GLA Energy Comments – Updated Design Response

9,11 & 19 Osiers Road, Wandsworth, London

Prepared by: Hollybrook Limited

September 2019

drawing title
LTHW ENERGY CENTRE SCHEMATIC

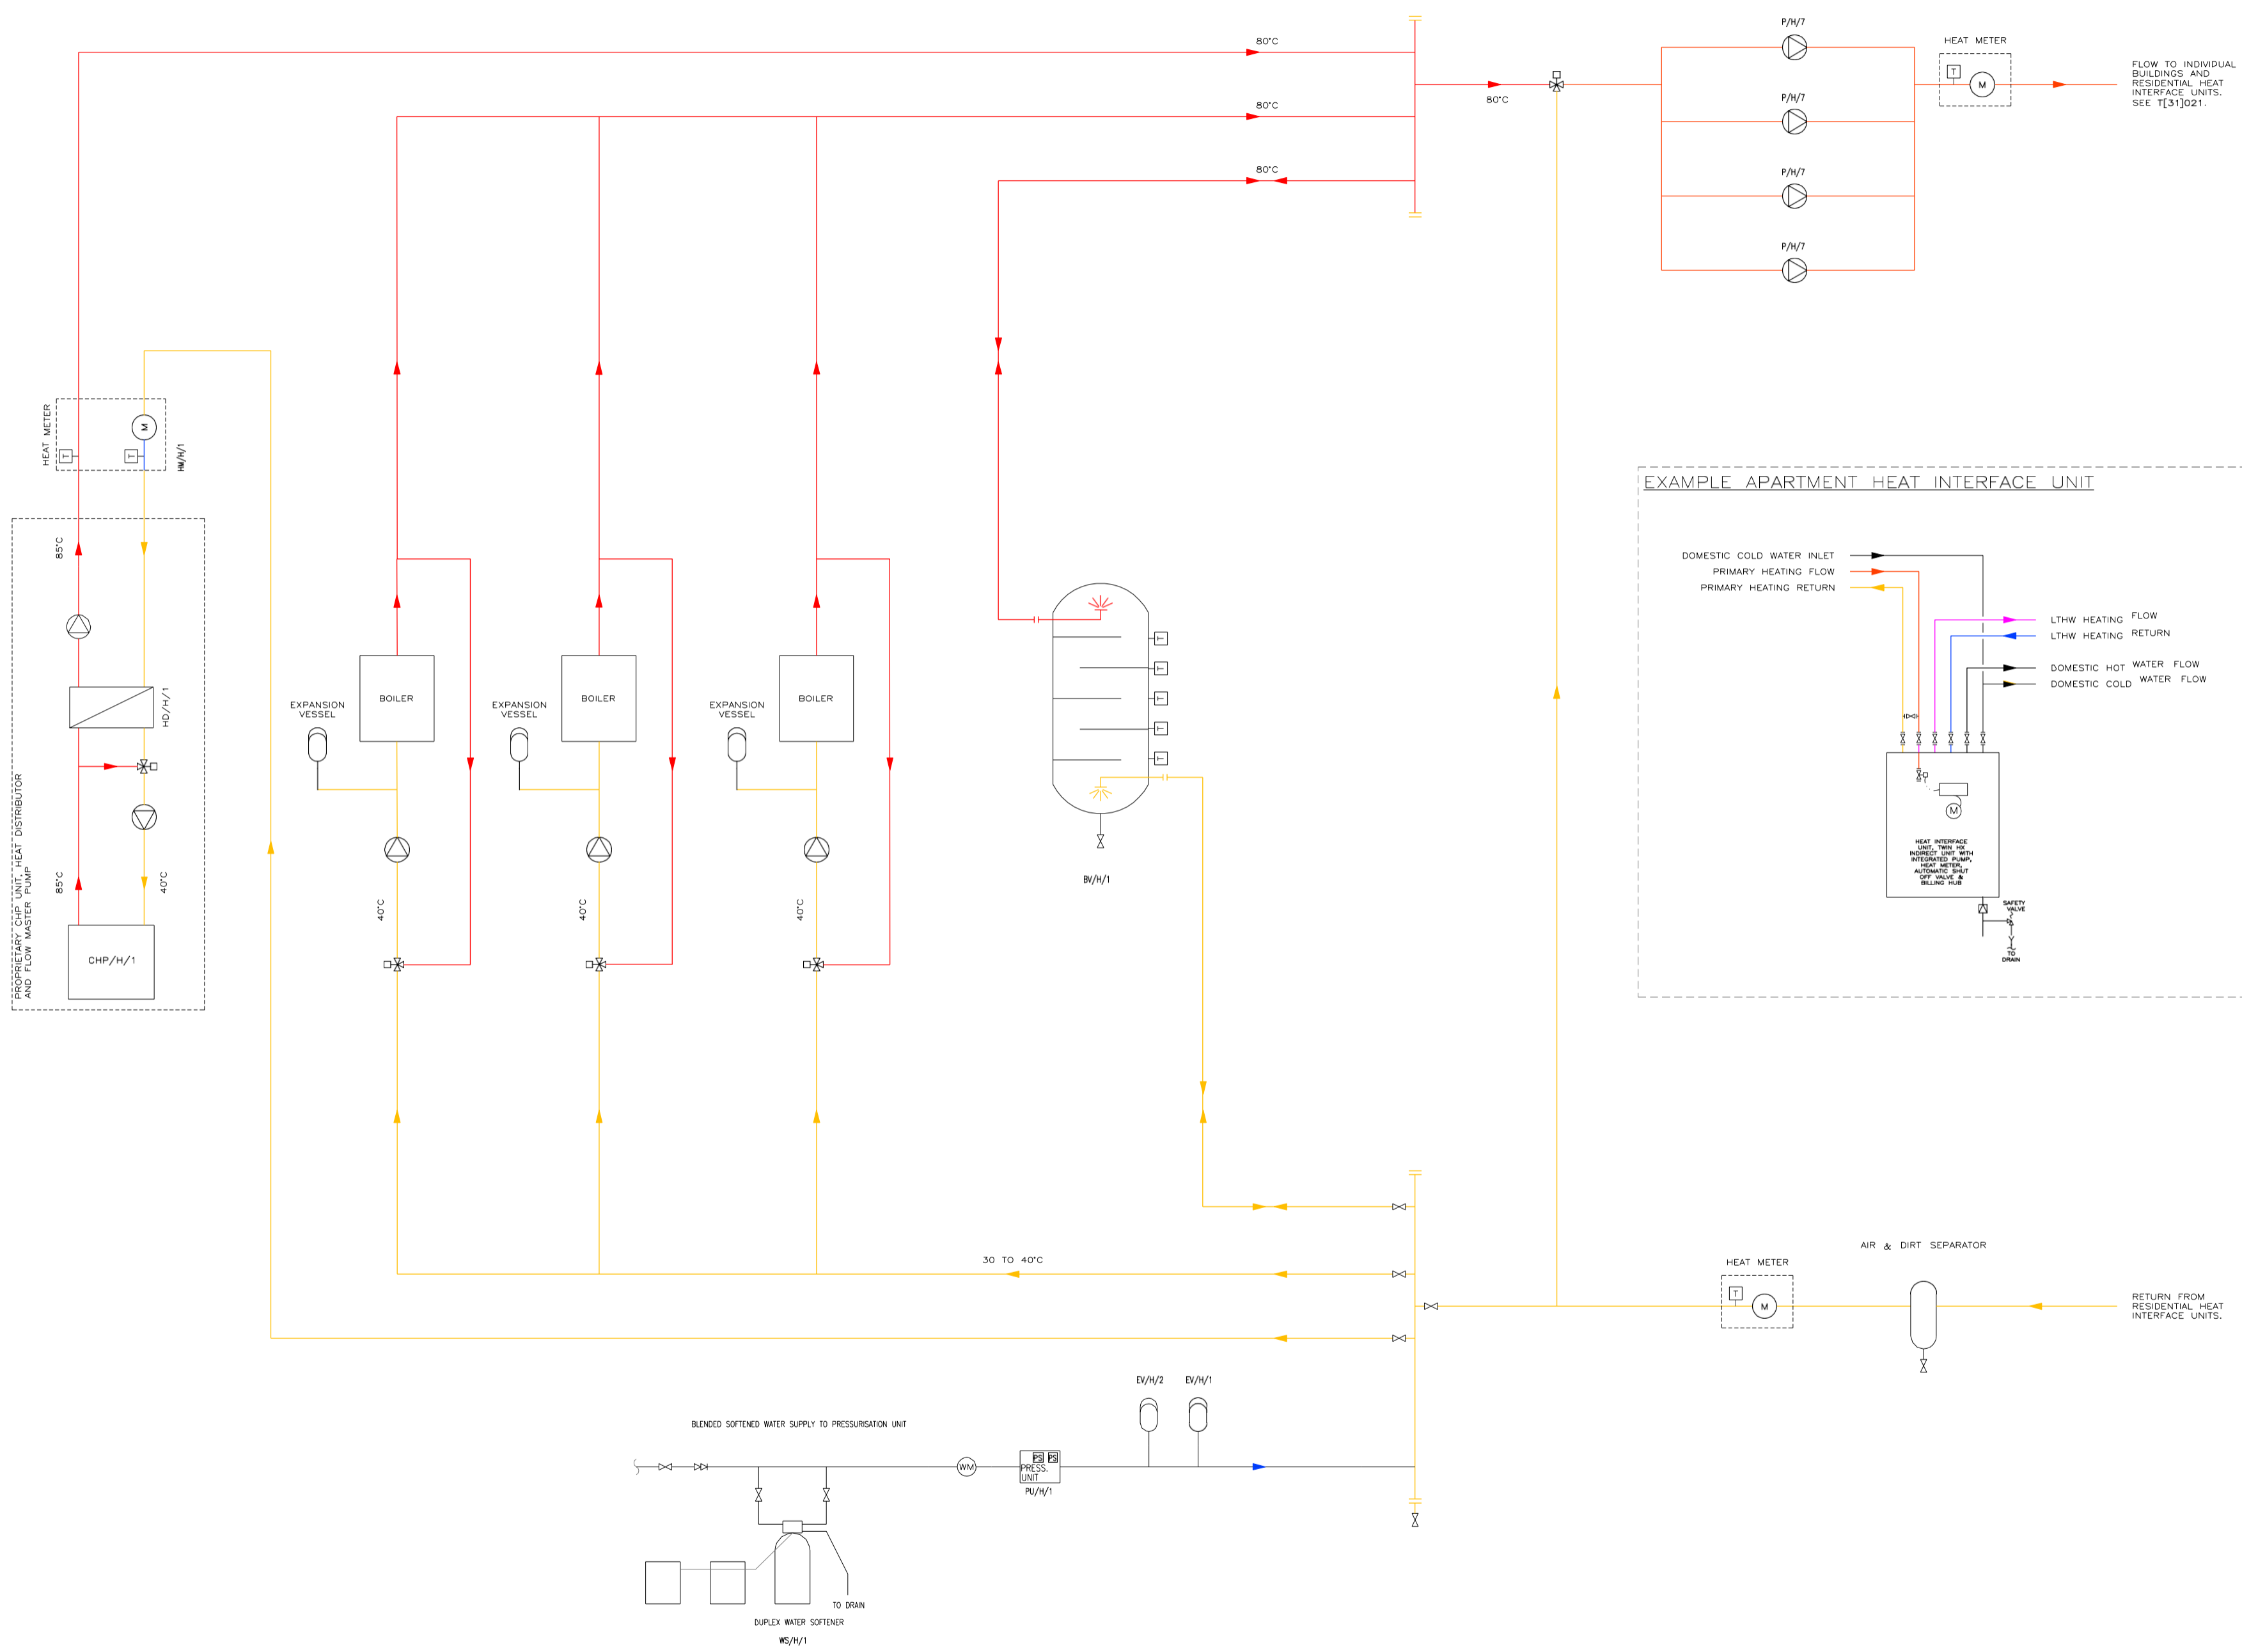
- 10. The applicant should be proposing a site heat network where all apartments and non-domestic building uses will be connected. A drawing showing the route of the heat network linking all uses/buildings on the site should be provided.**

The applicant has stated that the site heat network is proposed to supply all residential units. On the other hand, it has been stated that the commercial aspects of the scheme are to be provided with cooling for commercial purposes, due to their proposed usages. The alternative option of providing heating via the district scheme and cooling via centralised chiller systems was investigated, however found to be a less sustainable option, due to the lower efficiencies and greater distribution losses associated with such systems. The applicant needs to provide the associated heating demand of non-residential elements to justify the omission of connection to the DH network. Capped connections to the heat network will be provided for the non-domestic units; this should be demonstrated through appropriate drawings. All relevant drawings showing the route of the heat network should also be submitted. This item is still outstanding.

Two schematic drawings have been included in Appendix 2; one showing how capped connections shall be provided for the commercial uses and the other showing the route of the heat network.

The commercial spaces are being provided to shell only, therefore it would be the responsibility of the occupier to decide whether to connect to the capped heating connections or not.

Drawing
 Roof Floor Plan

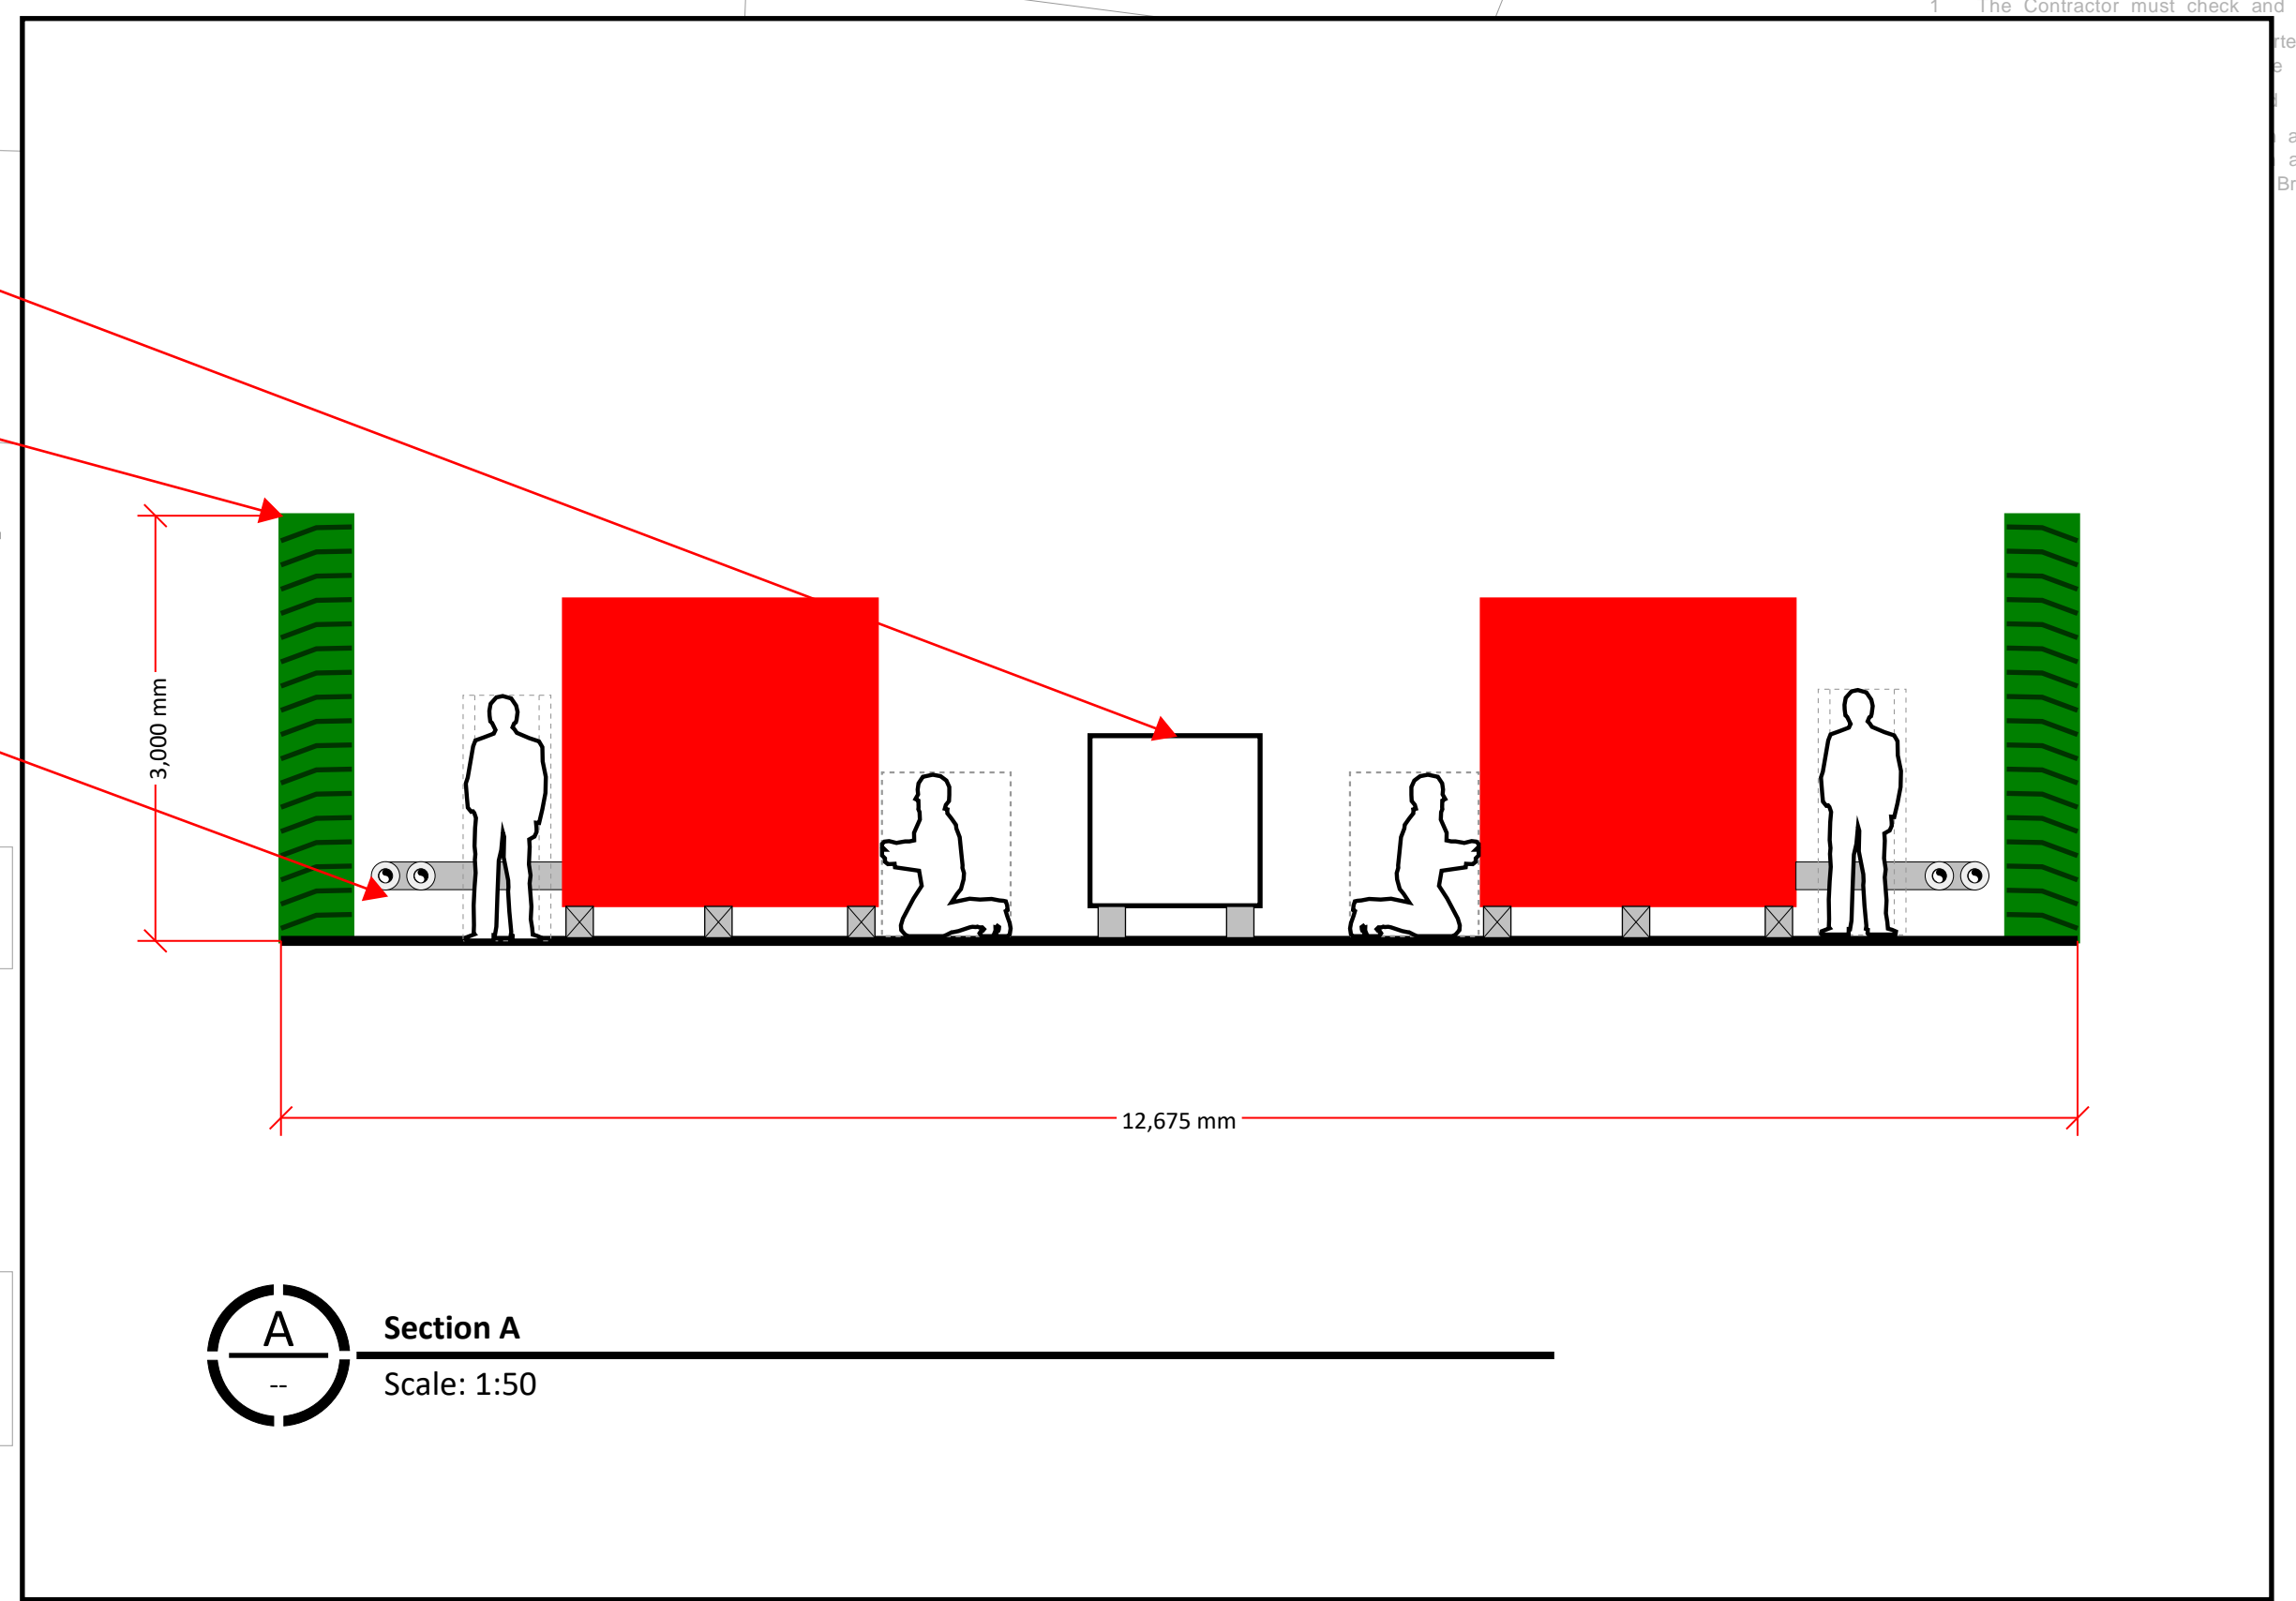
- 12. The applicant is proposing to install a gas fired CHP unit as the lead heat source for the site heat network. The CHP is sized to provide the domestic hot water load, as well as a proportion of the space heating leading to a 75% contribution. A reduction in regulated CO2 emissions of 55 tonnes per annum (20%) will be achieved through this second part of the energy hierarchy.**
- 13. Given the scale of the development, and in line with the GLA guidance on preparing energy assessments, a CHP-led heating strategy is not considered appropriate for the proposed development. The applicant should consider the potential of other, more appropriate, low carbon/renewable technologies that could supply the heating requirements of the site.**

The applicant has stated that the M&E design team have determined that CHP is a viable option for this development. If CHP were to be replaced with air source heat pumps the scheme would have to be completely redesigned for reasons associated with roof space and building height and general re-design of the heating distribution system. The information submitted is not considered satisfactory to dismiss a CHP alternative for the site. The applicant should carry out a detailed feasibility analysis for all potential heating options for the site and demonstrate their viability. Should a CHP be proposed, it should be demonstrated that the site will be future proofed for on-site low carbon replacement when the CHP is at the end of its life. This item is still outstanding.

For all system architecture types, plant space would be required at roof level. This will affect the structure and building massing. Considering system Option 1, a roof plant area of approximately 120sqm would be required for ASHP equipment. Additional riser space would be required of approximately 1sqm for riser pipework between the roof plant and the basement energy centre. The additional plant space would displace other uses for the roof, e.g. PV installations. A roof sketch showing the plant space requirements has been provided in Appendix 3.

The PV would need to be omitted from one of the roofs (see Appendix 3), leading to a drop in renewable generation and further increase in SAP emissions. The embodied energy of multiple ASHP units would be significantly higher than a single CHP due to additional pipework & ancillary equipment required.

Acoustic screen (dimensions to be confirmed by acoustician)

Approx. 1500mm zone required around each ASHP for pipework connections and maintenance access.

2no. ASHPs, each with dimensions approx. 4100W x 2200L x 2150H mm.

Coordination with smoke extract fan would be required

All PV on this roof omitted

Suggest acoustic screen is extended to form a single enclosure around all roof plant

Commercial roof plant relocated
